ADDENDUM 2

RE: Colusa Unified School District
Burchfield ES – TK / K and Standard Classroom Modulares
Studio W Project Number 25033

From: Studio W Architects
1930 H Street, Sacramento, CA 95811

MODULAR BID PACKAGE - ADDENDUM #2

Proposed Floor Plans - MODULAR BID PACKAGE

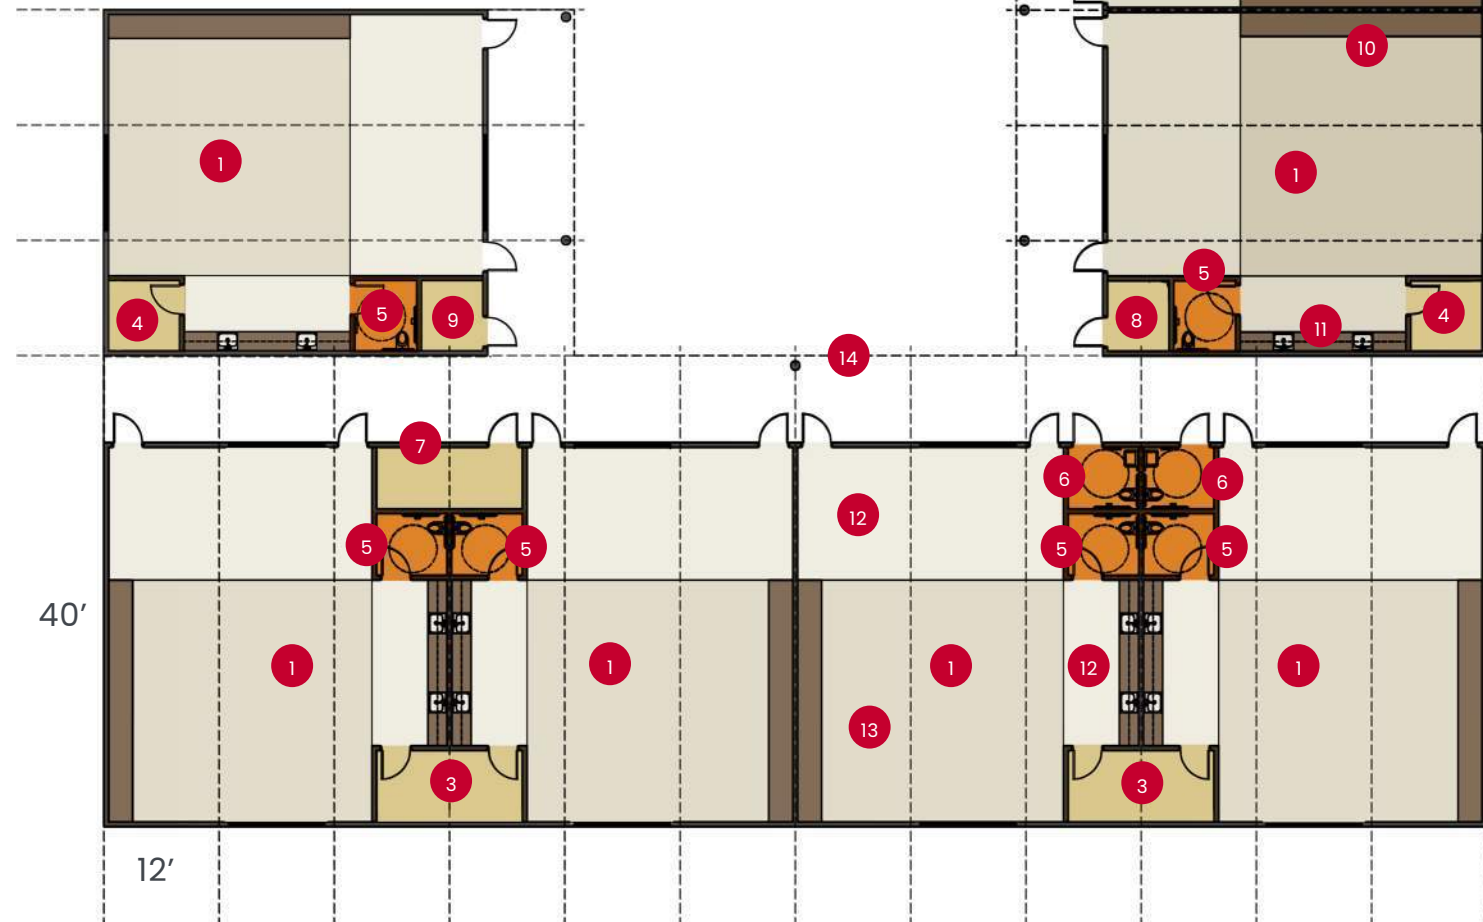
- a. Confirmed, the site contractor will provide the sanitary facilities.
14. The drinking fountain shown at the TK/K classroom is sitting on a modline. Please confirm that we are able to move it during design.

32. The SQFT for the standard classroom is not correctly called out. Please advise.
 - a. Standard classrooms are 24'-0" x 40'-0" and TK / K classrooms are 36'-0" x 40'-0" as per page 2 of the drawings.

- a. New buildings should be integrated with the existing solar panel canopy.
34. Deductive Alternative #1 – Please confirm what this includes. It appears to represent two fewer 40'x24' classrooms—please confirm if that understanding is correct.

- a. Project does not require sprinklers per Question #22, however if Option 2 is selected for the TK/K Building, locate as noted on Page 2 of plans.
40. Questions regarding Bid Form.

- a. Confirmed you are able to move the drinking fountain, but district is to approve final location and shall conform to all Code requirements, including accessibility.

- a. This is correct.
35. Alternate Qualifications – What are the qualifications for the deductive and additional alternates?
 - a. If the bids received align with the District's budget.

Exterior Elevations - MODULAR BID PACKAGE

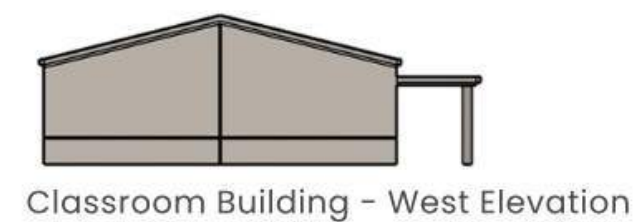
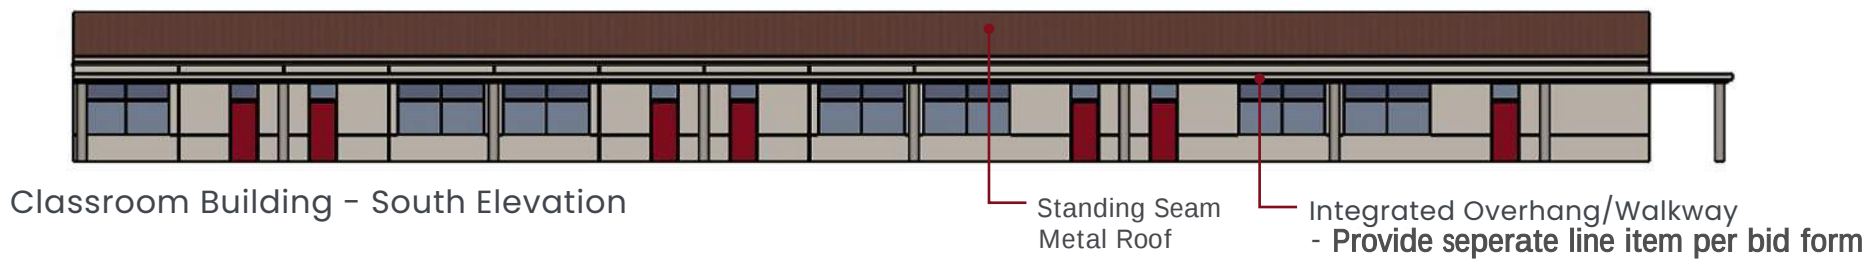
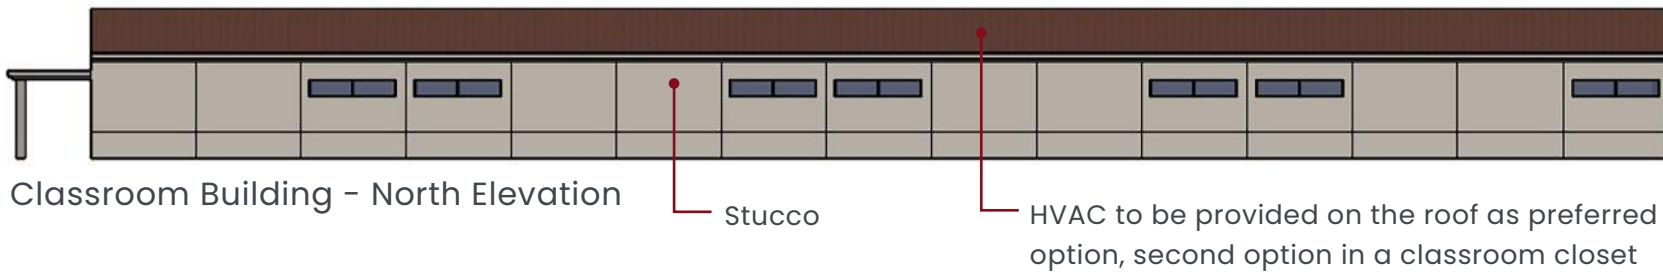
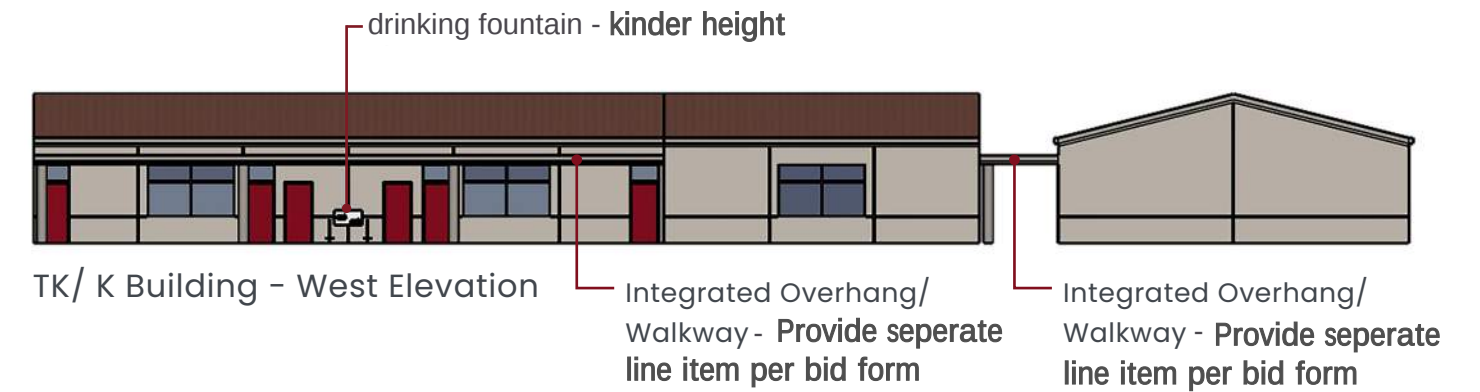
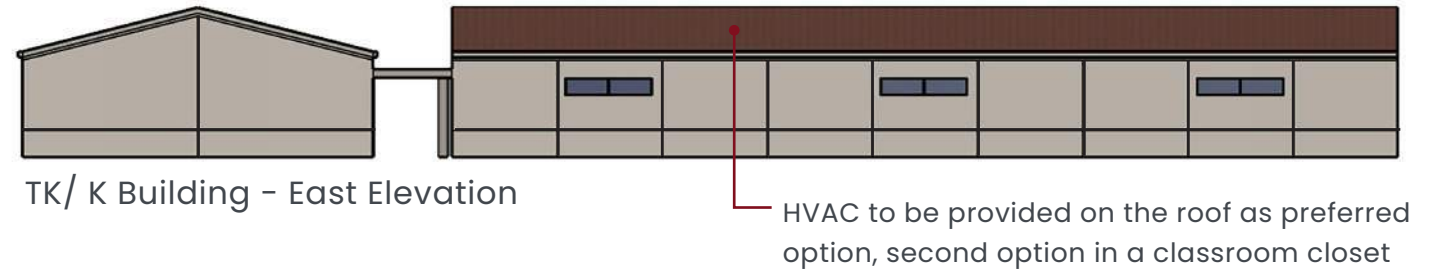
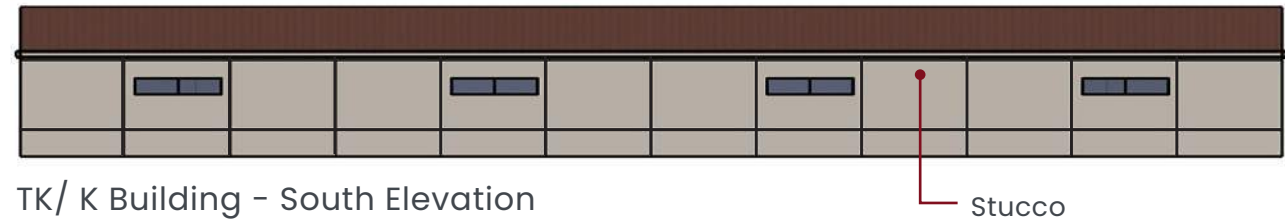
- a. Confirmed, the site contractor will provide the traffic control.
21. Please confirm that a modular manufacturer's DSA approved PC with 2:12 roof pitch will be acceptable for these buildings.

- a. District is looking for high windows on the exterior side (street side) of the modulares. If you cannot provide as shown, provide a sample elevation of what you can provide in the bid documents.

- a. The 2:12 roof pitch is acceptable. Provide an alternate for asphalt shingle roofing as well as the standing seam metal roof.
22. Please confirm that fire sprinklers will be required.

RED STANDING SEAM METAL ROOF
PROVIDE ALTERNATE FOR
ASPHALT SHINGLE ROOF

FLOOR PLANS - MODULAR BID PACKAGE

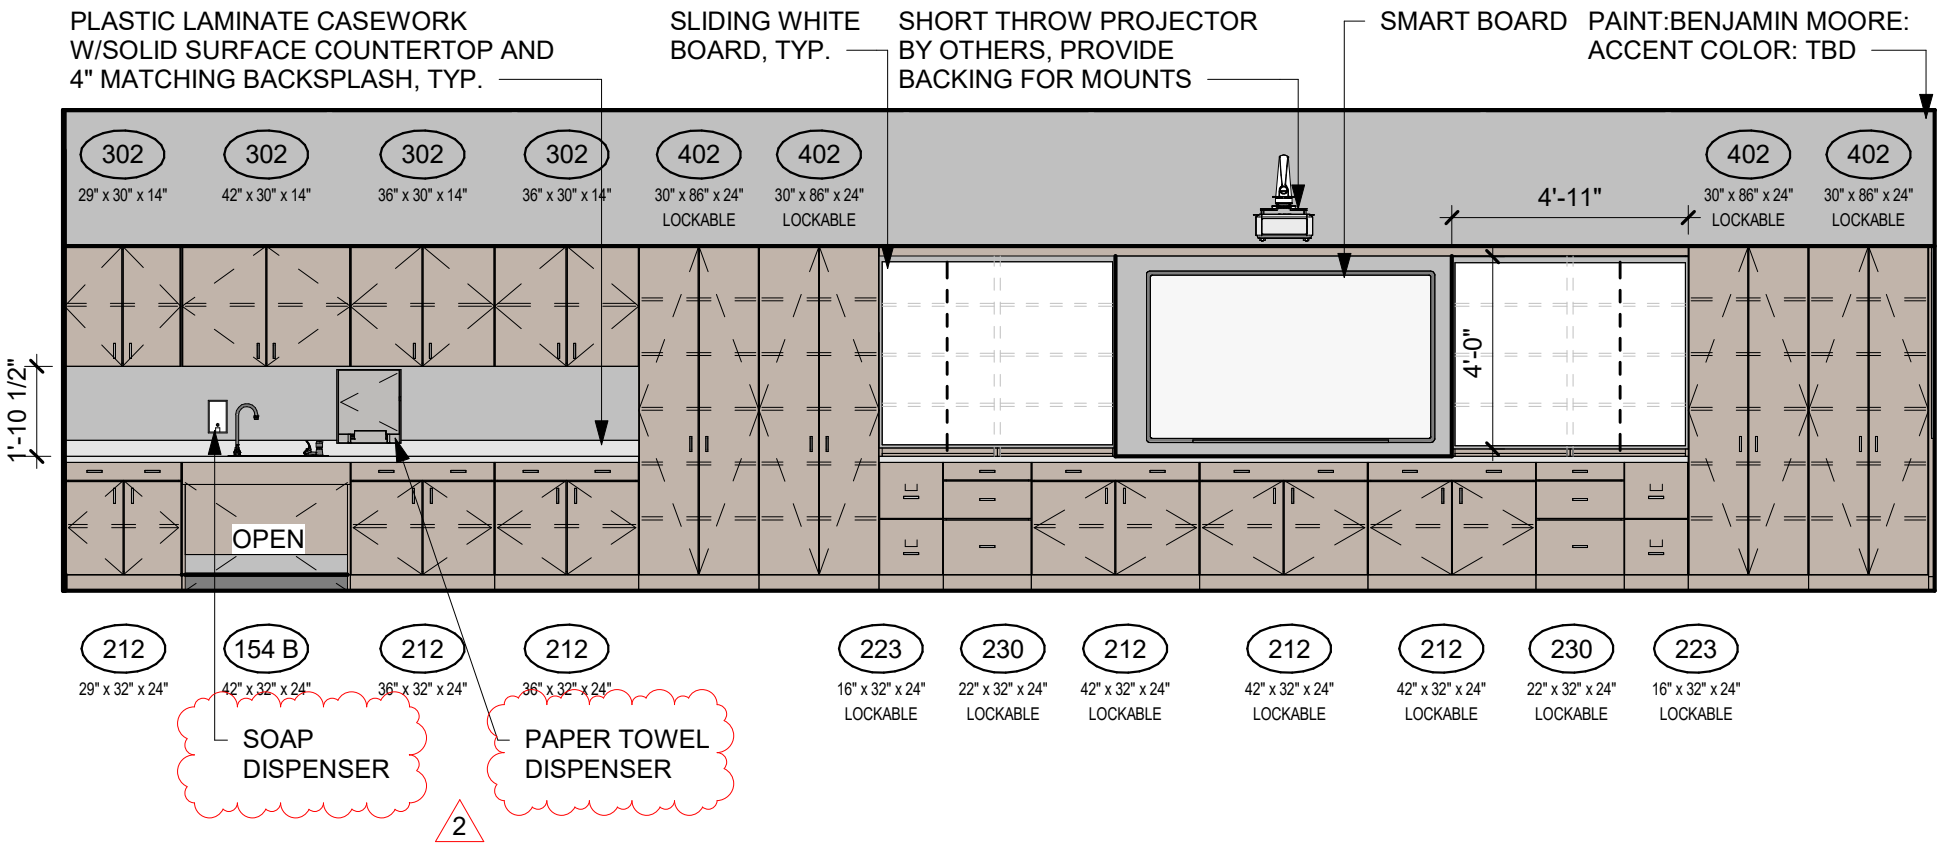
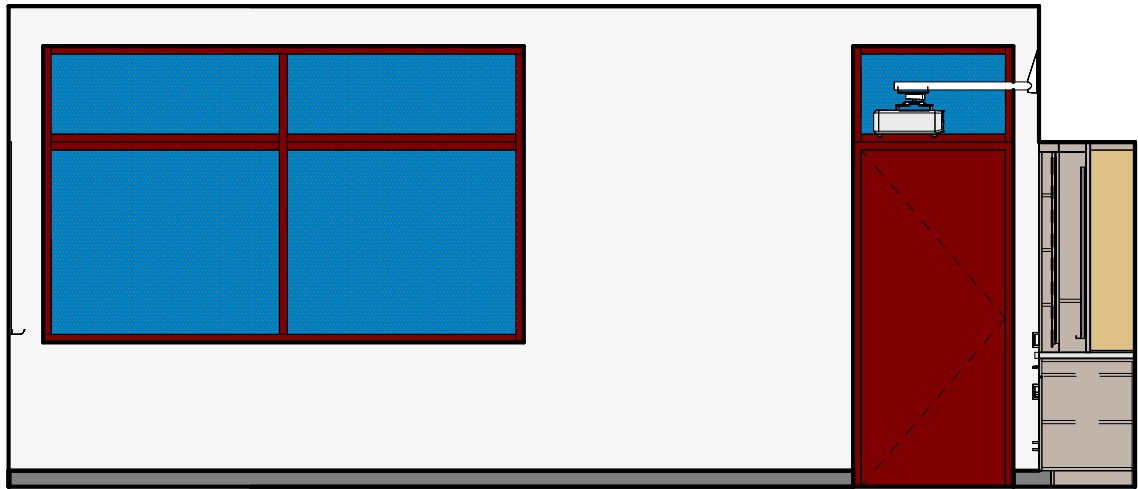
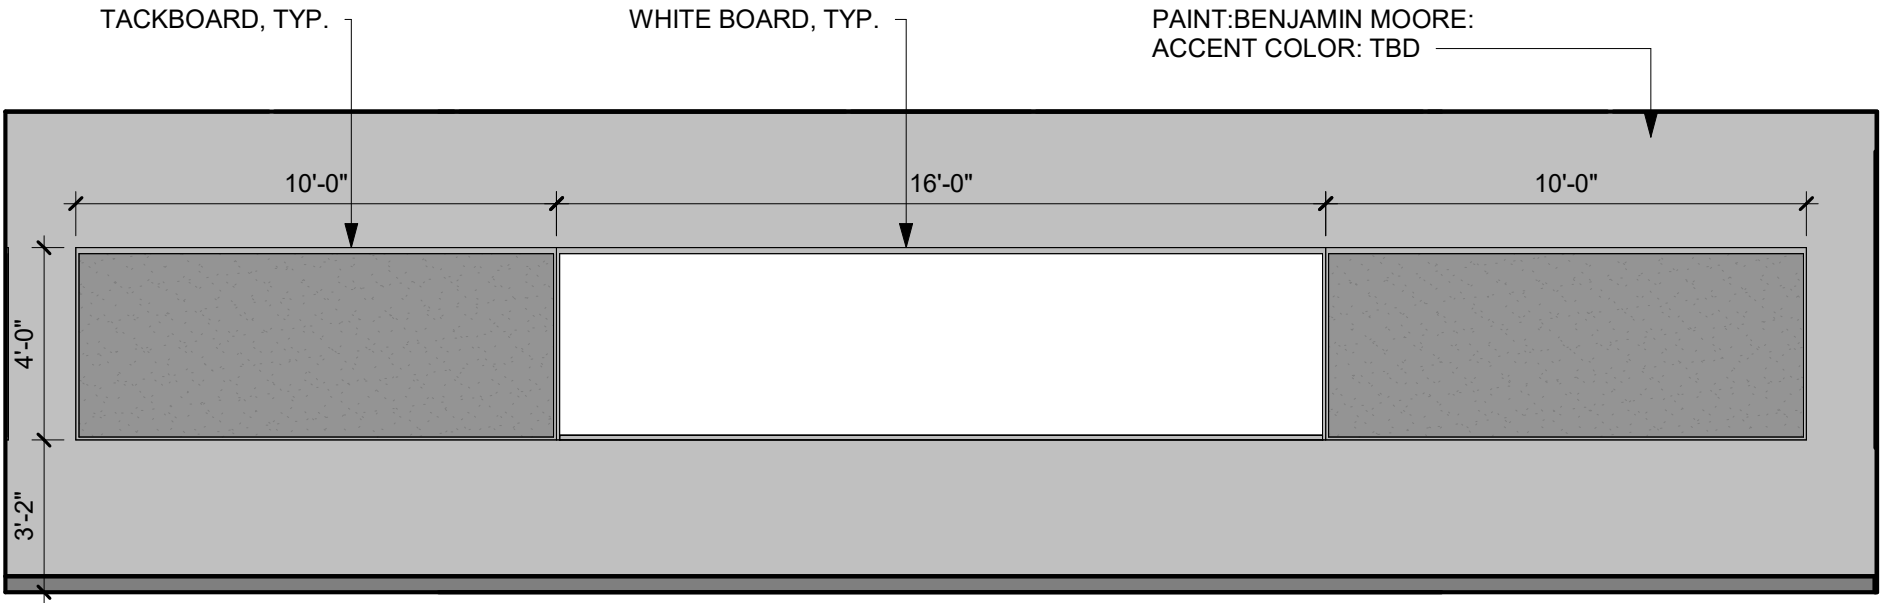
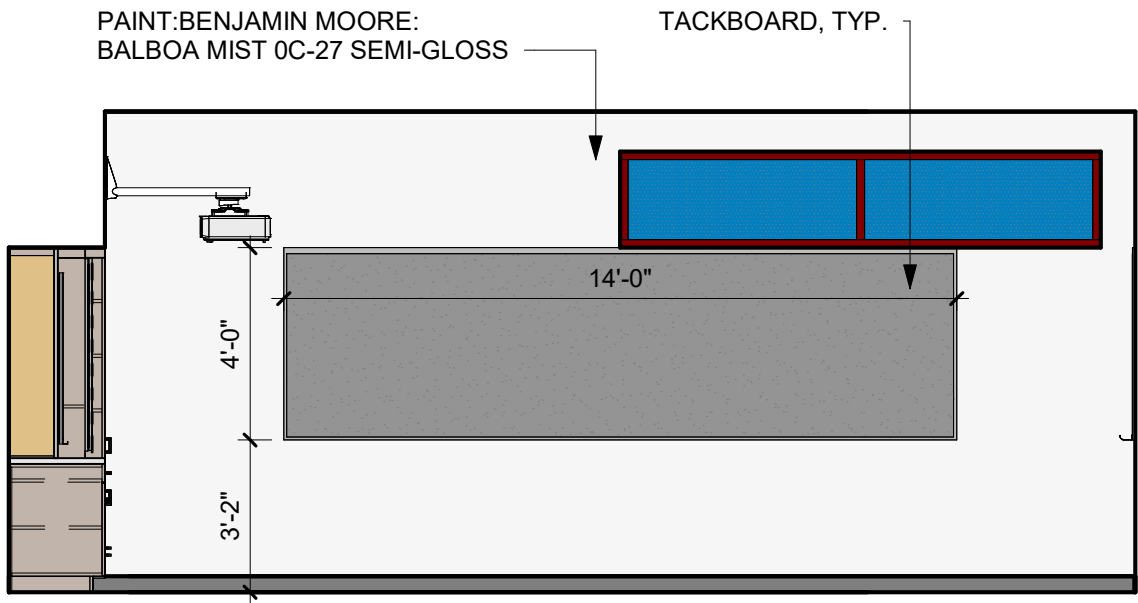
46. Will a 2:12 gable roof pitch be acceptable?
 - a. See Question #21.
47. What are the wall finishes in the restrooms?
 - a. Preferred wall finish is epoxy up to 6’-0” high in splash areas. Provide alternate price for FRP panels on all restroom walls.

48. Please provide a door and window schedule.
 - a. For Door Schedule, see Note on Sheet 4 of plans – All doors are to be 3’-0” x 7’-0” with accessible lever hardware. For Window Schedule, see Sheet 4 of plans with the 3 different window types.

STANDARD CLASSROOM INTERIOR ELEVATIONS - MODULAR BID PACKAGE

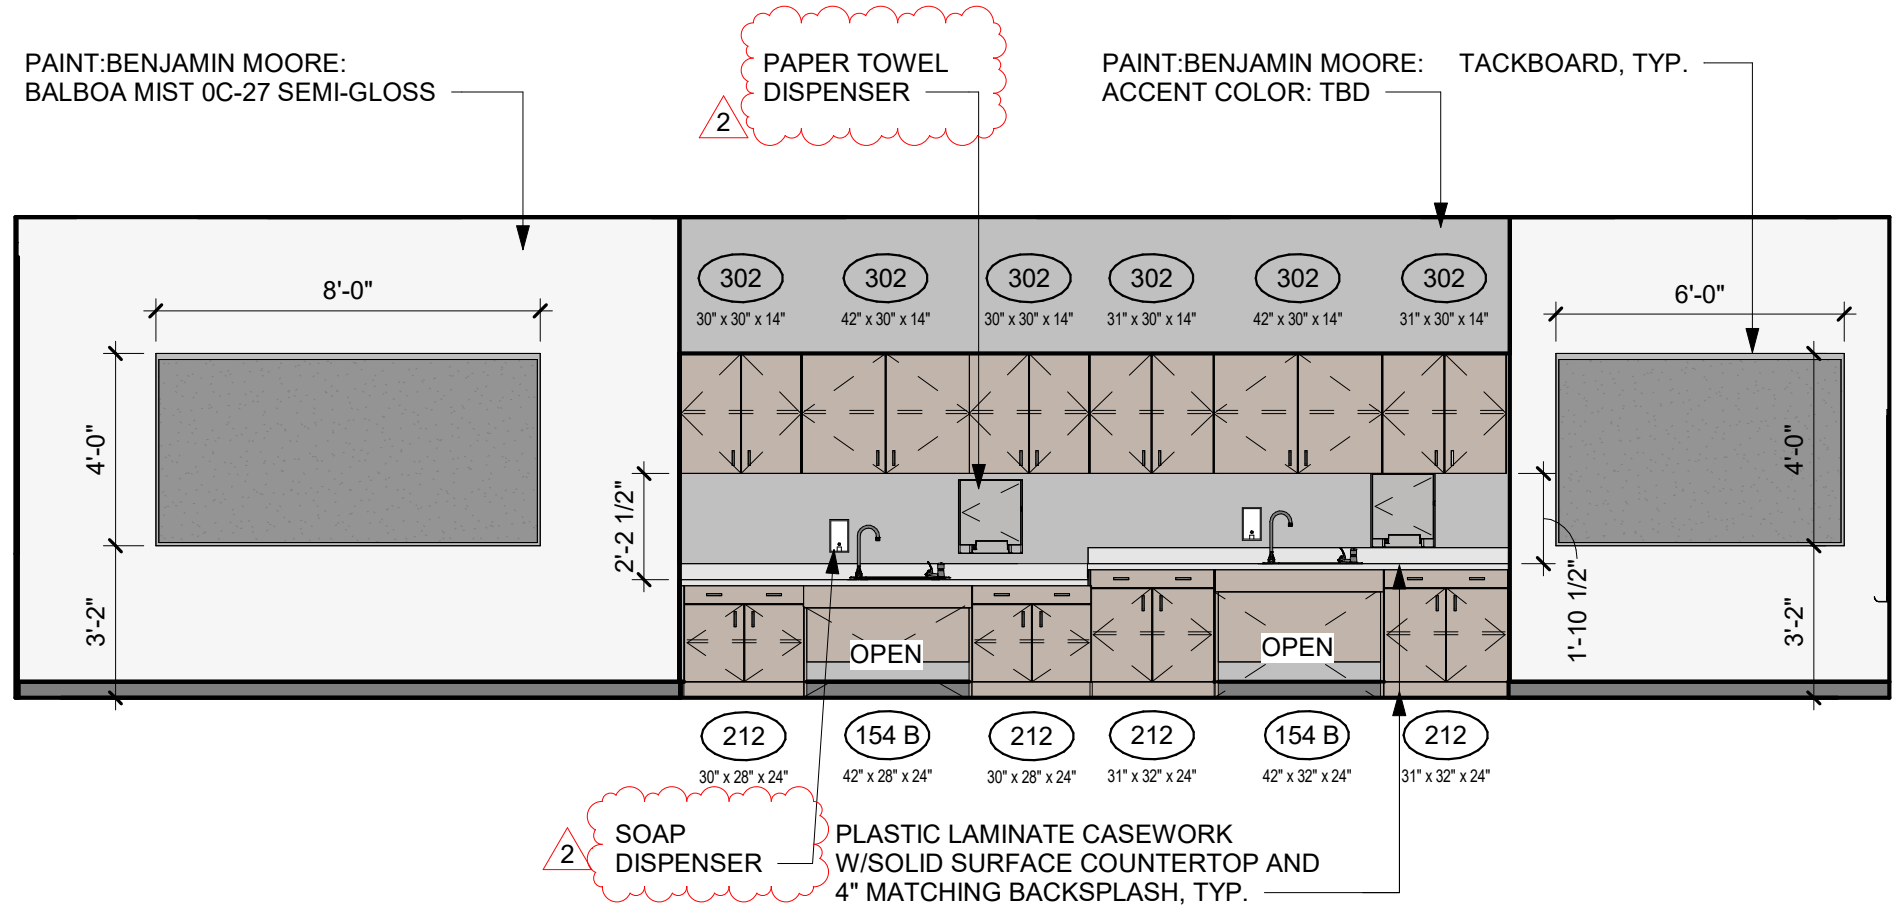
30. The interior elevations show something mounted above a counter. Please confirm what that is and that the modular manufacturer is to provide blocking only for it.

- a. The item above the sink countertop is a paper towel dispenser. Please provide blocking for unit. These items are to OFCI.
31. Windows over the tackboard will not work as currently drawn. Ceiling height is too high. Please advise.
